REQUEST FOR BIDDING INTERPRETATION (RFBI)

PMDB RFBI No.: 6

Project No.: 000000000008666
Project Name: DSH-Coalinga Hydronic Loop Replacement
Location: Coalinga, CA

Drawing Reference: Civil Sheet C-4.3

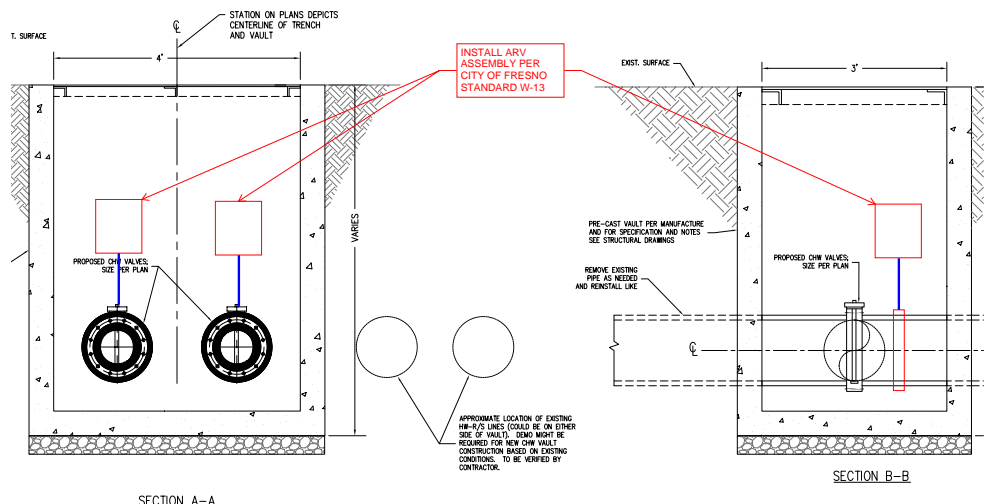
Question: Note 22 on the plan sheets states to install the ARV inside a gate valve vault per Detail 6/C-4.3. However, there is no Detail 6 on Plan Sheet C-4.3.

Can the plans be revised to include a detail showing the ARV installation within the valve vault?

Response: Install ARV assembly per the attached City of Fresno Standard W-13. Use only the portion of the detail W-13 indicated.
